Case No. 20-DDP-0024 Binding Elements from March 25, 2021 LD&T:

Case No. 21-VARIANCE-0006 Condition of Approval from March 29, 2021 BOZA Meeting

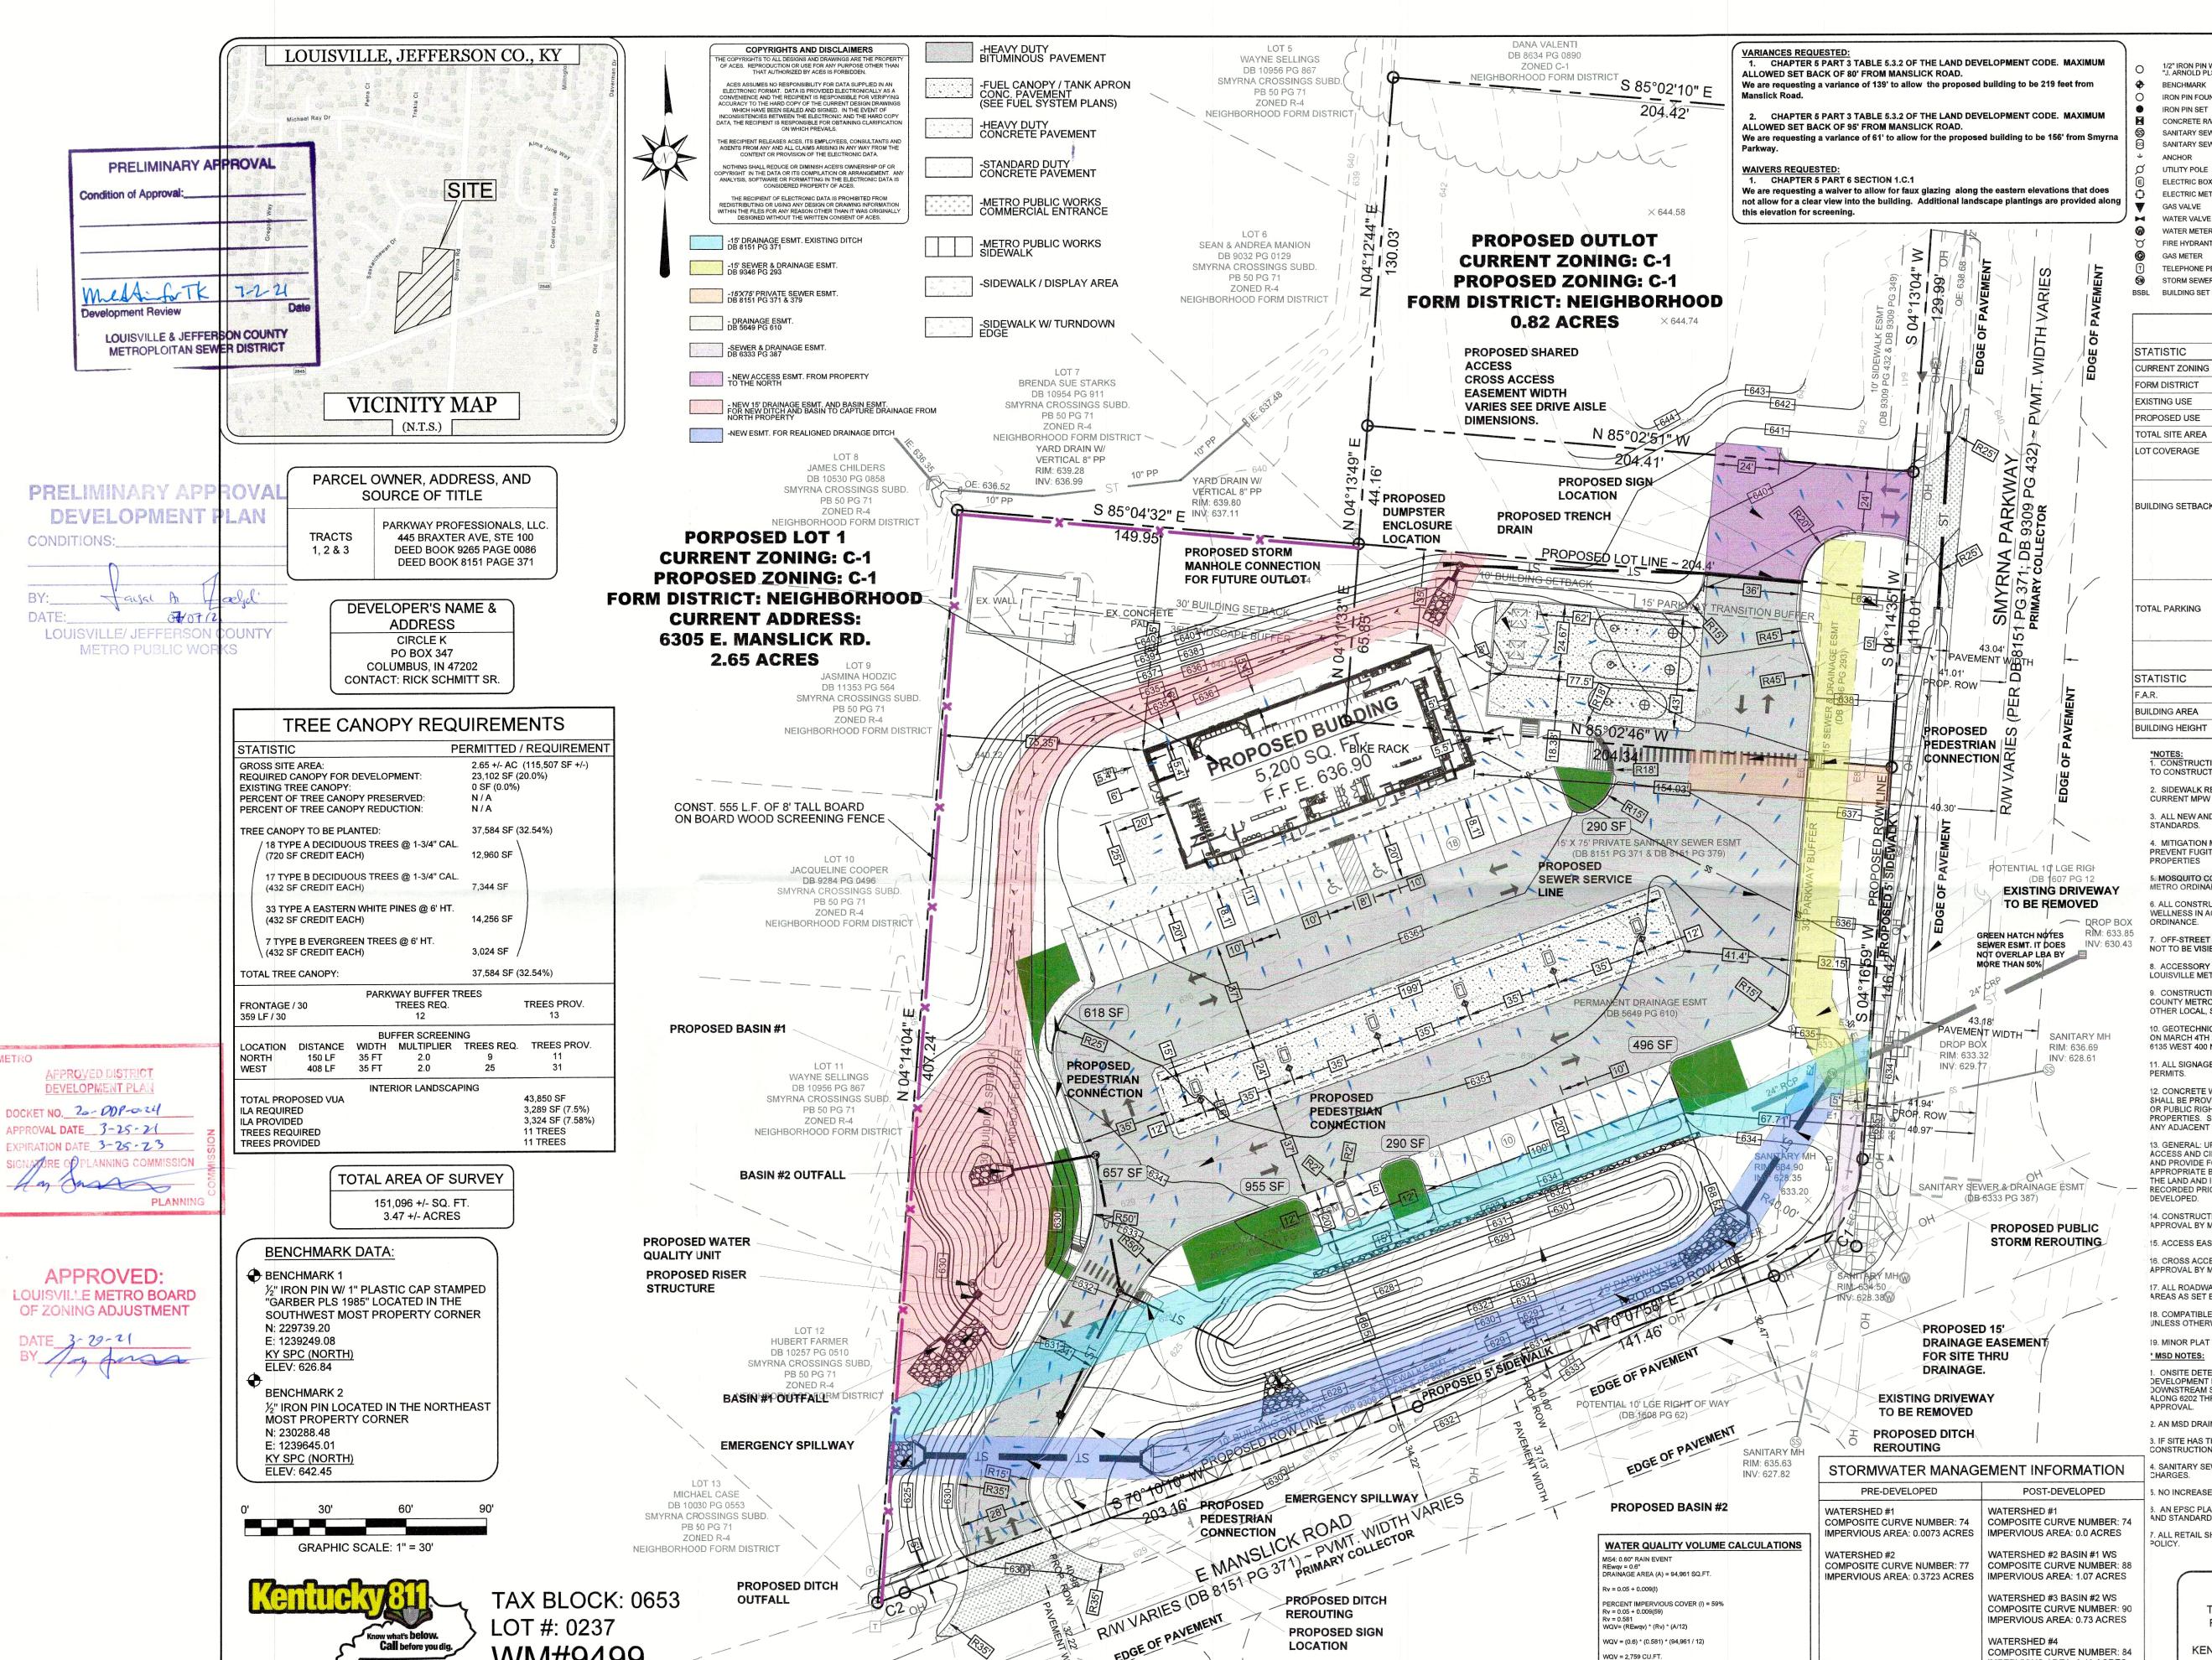
RESOLVED, the Louisville Metro Land Development and Transportation Committee does hereby **APPROVE** the requested Revised Detailed District Development Plan, subject to the Board of Zoning Adjustment approval; **ON CONDITION** that the pedestrian connection be shifted to pass through the ILA area and not behind the gas pumps as discussed; and **SUBJECT** to the following binding elements:

- 13. The applicant shall install an 8' solid wood screening fence and enhanced landscaping as proposed on the Landscape Exhibit presented to the Land Development and Transportation Committee on March 25, 2021. Final location and type of additional plantings will be shown on the approved landscape plan.

1. The applicant shall extend the fence to the north corner of the property line as discussed in today's meeting (March 29, 2021.)
